Thank you very much for your latest test results. Unfortunately I do not fully understand your measurements. I will try my best to explain what I have understood in the attached document. Please read it through and correct me if I have misunderstood any point.

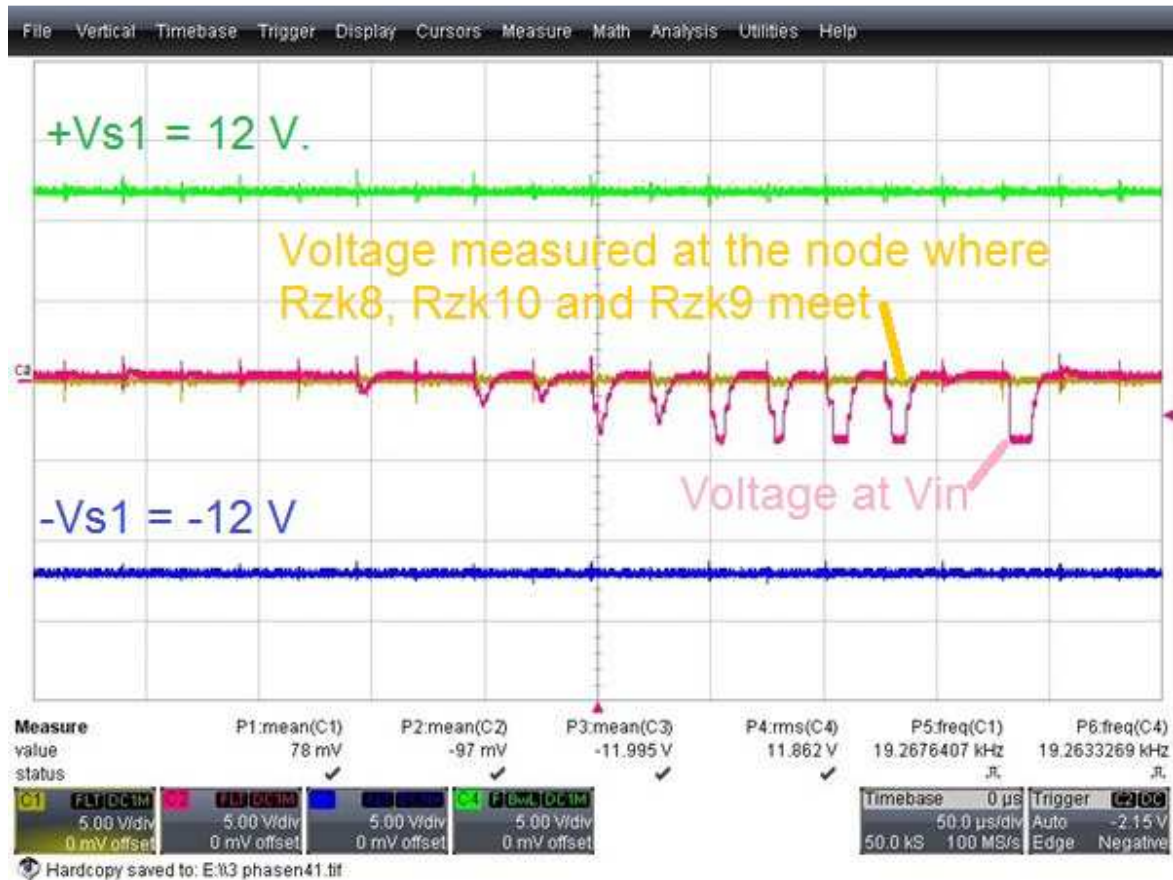
On the image below: could you please confirm that my labels are accurate?

I assume that you have no connection in your PCB between GND1 and GND2. If that is the case, could you please include another oscilloscope capture of the “+Vs2” with respect to “GND2”, “-Vs2” with respect to “GND2” and “Vout” with respect to “GND2”? Please make sure no terminal of your oscilloscope probes (probe or ground clip) touch the pins on the +Vs1/-Vs1/Gnd1 side.

Could you also please verify that the new external supplies you are using are isolated from the supplies you are using for +Vs2 and -Vs2? If not, could you use batteries in order to supply +Vs1 and -Vs1 on the one side and +Vs2 and -Vs2 on the other side?

Also, you mentioned that adding 24 uF from +Vs1 to Gnd1, and -Vs1 to Gnd1 has helped but you do not mention including any capacitance directly between +Vs1 and -Vs1 as I recommended on March 6th. Could you please add this capacitance and also add decoupling capacitors between +Vs2 and Gnd1, -Vs2 and Gnd1, and between +Vs2 and -Vs2. Altogether, capacitance should be added to six places. Let me know if this is not clear.
